Change Notice No.	Notification date	Implementation date
CN/19/004	June 05, 2019	July 05, 2019

Subject : New design of vent/drain valves of mdi Large Capsule Filters

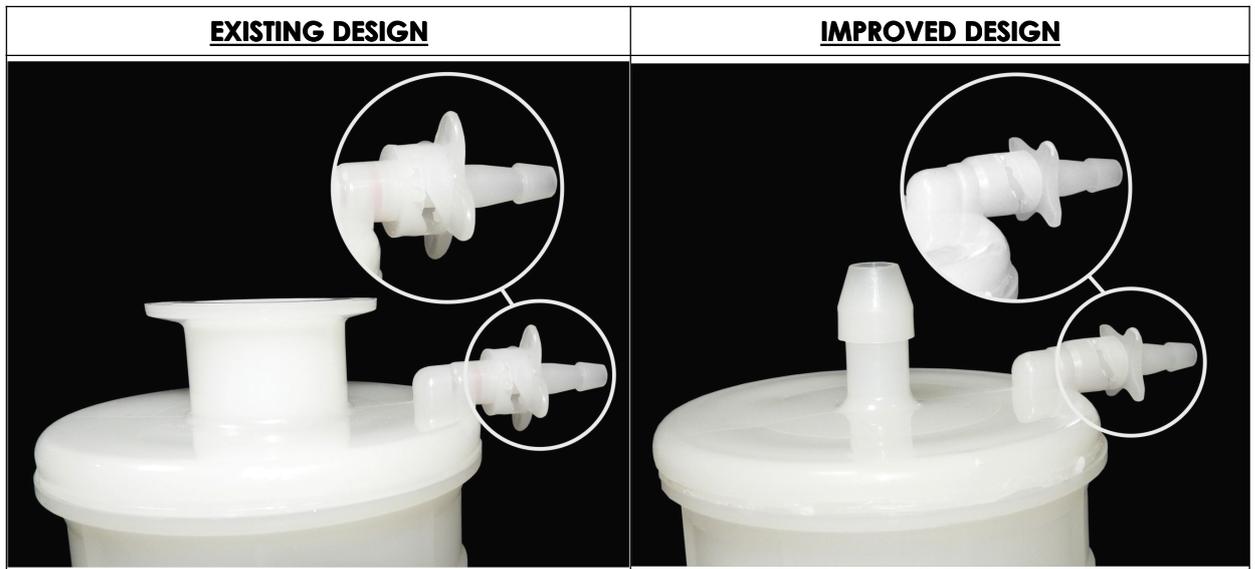
In our efforts to provide the user better products which are more convenient to use and deliver better performance, certain changes have been made in vent/drain valves of **mdi** Large Capsule Filters with catalog numbers as mentioned above.

The existing vent/drain valves of **mdi** Large Capsule Filters with catalog numbers as mentioned above are validated to perform the venting operation during use. After venting operation, these vent/drain valves need to be closed/tightened in order to prevent leakage through vent/drain valves. It was observed that when existing vent/drain valves were closed using excessive force, it sometimes used to get deformed/damaged resulting into leakage through the same. To overcome this problem/issue, the vent/drain valves of **mdi** Large Capsule Filters have been made more robust through improvement in design. The new design of vent/drain valves has been verified for critical product performance parameters including functionality and ability to withstand excessive force during venting operation. No change has been done in any other critical dimensions or materials of construction or manufacturing process of **mdi** Large Capsule Filters.

From a practical point of view the changes done will improve the ability of vent/drain valves to withstand excessive force during venting operation of **mdi** Large Capsule Filters. All performance specifications and product attributes will remain unchanged, except the improved design of vent/drain valves.
